<b>Project Name:</b>	Land at the Former Sipson Garden Centre, Sipson
<b>Document Reference:</b>	507.0010/HRN/2
<b>Document Name:</b>	Highways Response Note
<b>Prepared By:</b>	Izzie Drohan (April 2024)
<b>Checked By:</b>	Caitlin Turley (April 2024)
<b>Approved By:</b>	Kim Hammonds (April 2024)

1.1 This Highways Response Note (HRN) has been prepared by Paul Basham Associates on behalf of Bidwells to address highways comments received by both London Borough of Hillingdon (LBH) and the Greater London Authority (GLA) in relation to a planning application submitted (under planning ref: 67666/APP/2023/3721) for a B2 use class development comprising a specialist vehicle servicing site totalling 1,450sqm at the Former Garden Centre, Sipson Road, Sipson. The site location is shown below in **Figure 1**.

TOW TRUCK WITH CATERING VEHICLE  
ROUTE TO SITE FROM M4 SPINE ROAD

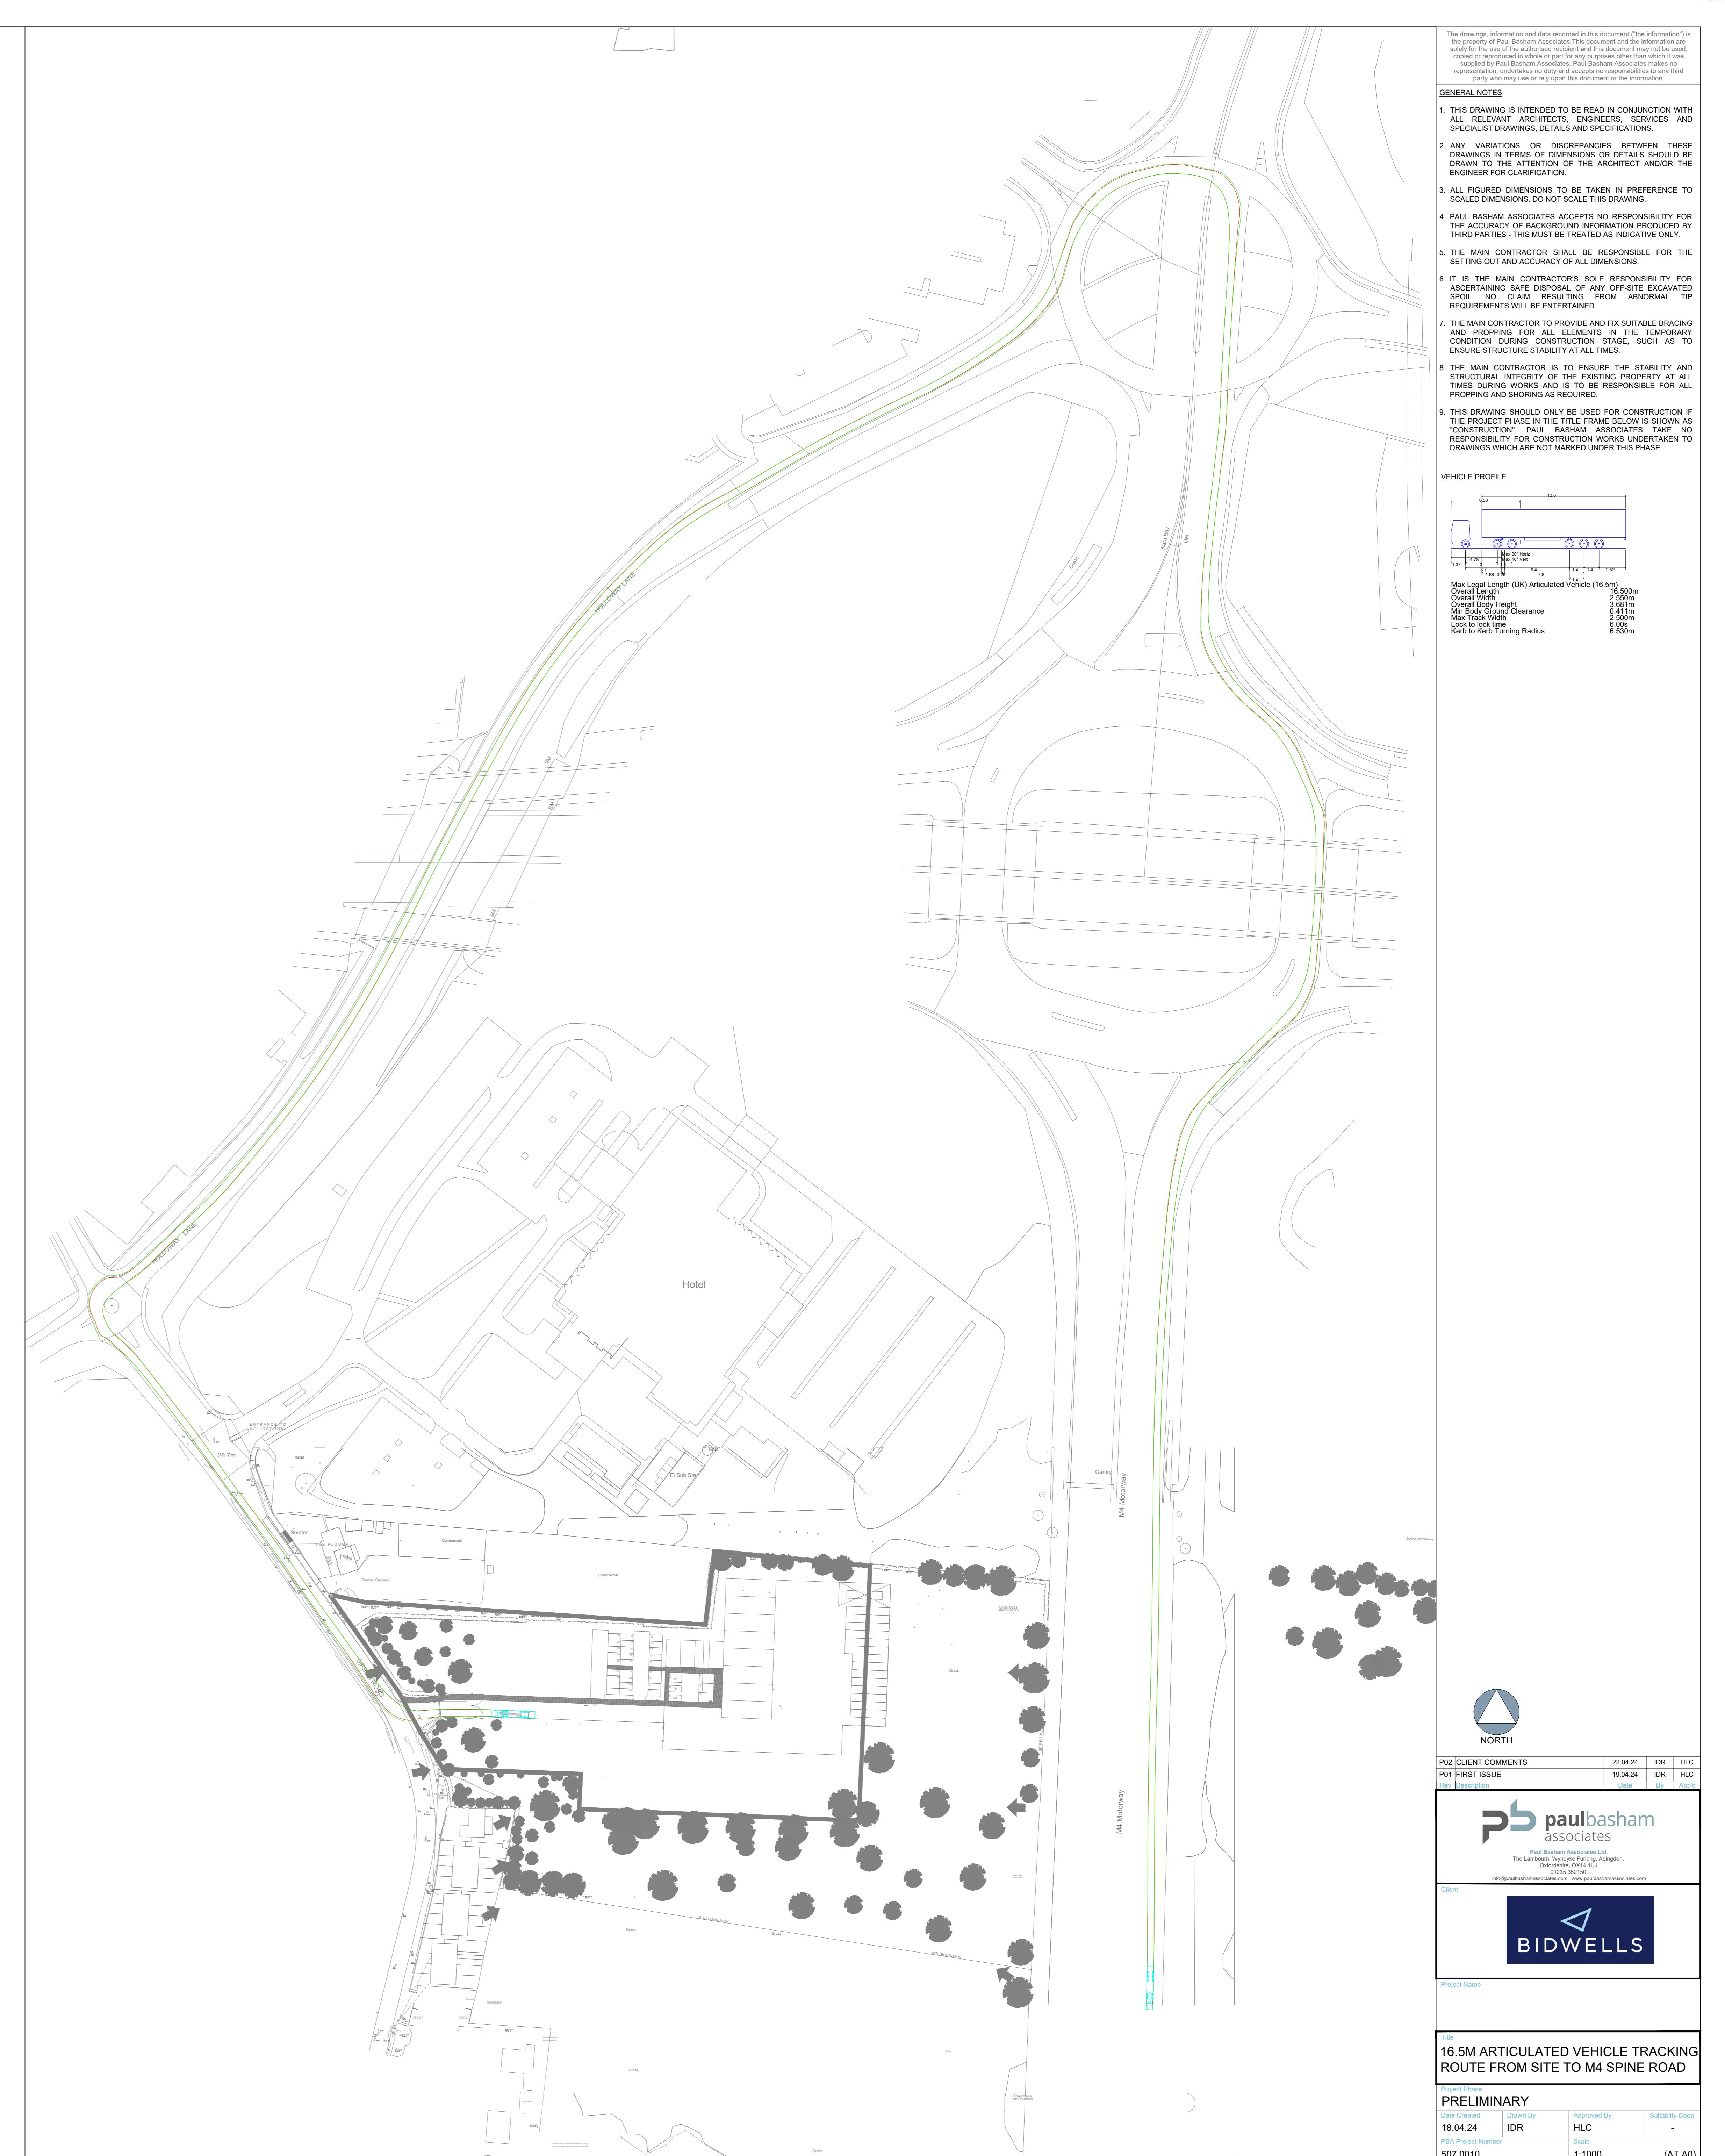
2.1 HBC stated in their response that *“further details on the types of airside support vehicles that would be serviced at the application site would be required along with swept path analysis for these vehicles which as Heathrow is a large airport, should show all airside gates and routes that would be used to access the application site”*.

Concerns are raised, however, regarding the type of airside support vehicles that would be serviced at the application site and the means in which they would gain access between Heathrow and the application site, either by being driven or transported on low loaders. The Planning Statement dated December 2023 Paragraph 10.43 states '*The Transport Assessment concludes that the development will generate way fewer trips than the consented use and should therefore represent an improvement to highway safety and operation*' which is accepted in part as the site would be likely to generate less vehicle movements to and from the application site than the approved garden centre use, however, airside support vehicles can be large, rigid, wide and heavy. Further details of the types of airside service vehicles that would be serviced at the application site would be required along with swept path analysis for these vehicles which, as Heathrow is a large airport, should show all airside gates and routes that would be used to access the application site.

2.2 Information has been provided from the operator outlining the type of vehicles that will be recovered and transported to the site and is outlined within **Table 1**. The operator has stated that all vehicles outlined in **Table 1** will be transported on the low loader, with the exception of the Catering Vehicle (“Mallaghan”), which would be transported via the Tow Truck.

2.3 Therefore, a swept path analysis drawing showing the proposed routing of the vehicles, including a 16.5m articulated vehicle and the catering truck/tow truck has been completed, and is attached as **Appendix B**. It is worth noting that as the catering truck would be repaired upon leaving the site, only the route from Heathrow has been shown as the tow truck would not be required for the return journey.

Client	Lewdown Holdings Ltd
Project Name	Heathrow Garden Centre Sipson Road
Drawing Title	Sketch Site Plan
Drawn By	JF
Scale	1:500
Drawing No.	10760 .01
Revision	N

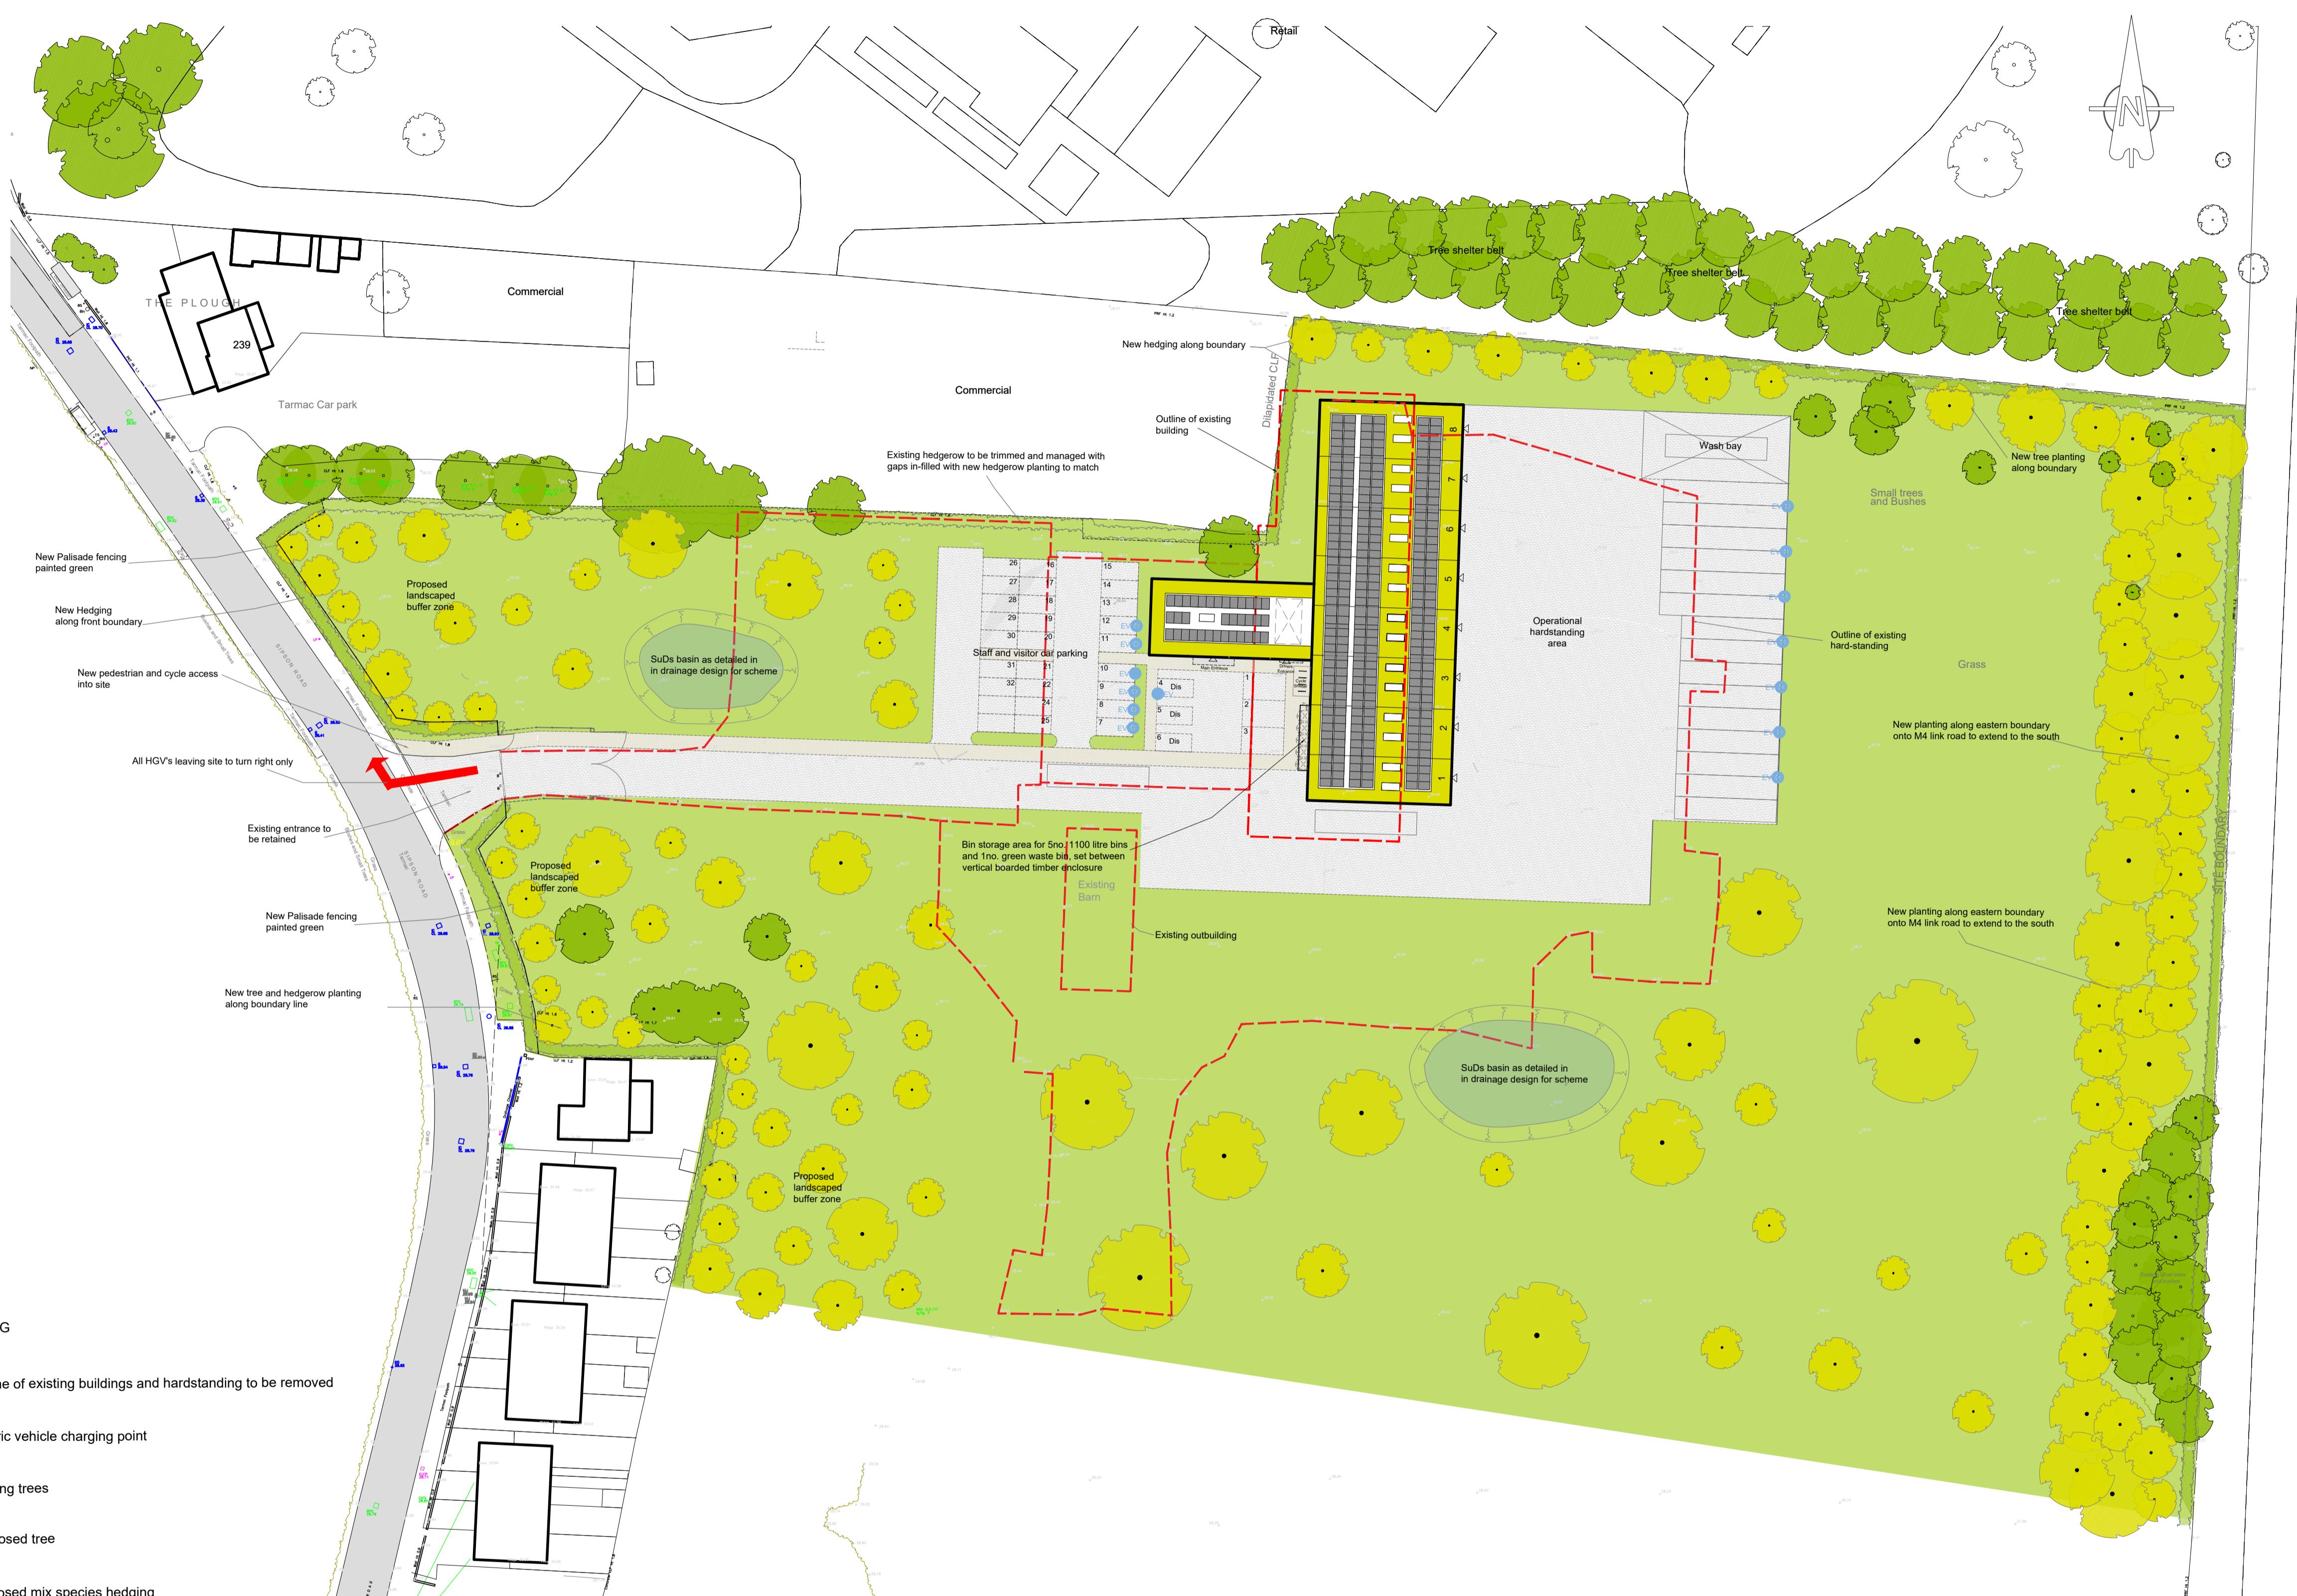
3.1 LBH requested that "*The amended access should be shown on the revised drawing*" whilst the GLA requested that "*The applicant is requested to provide specific details regarding the pedestrian and cycle access arrangements, including safety information*".

3.2 As demonstrated within the site layout (attached as **Appendix C**), the site will provide a segregated footway/cycleway on the northern side of the access road.
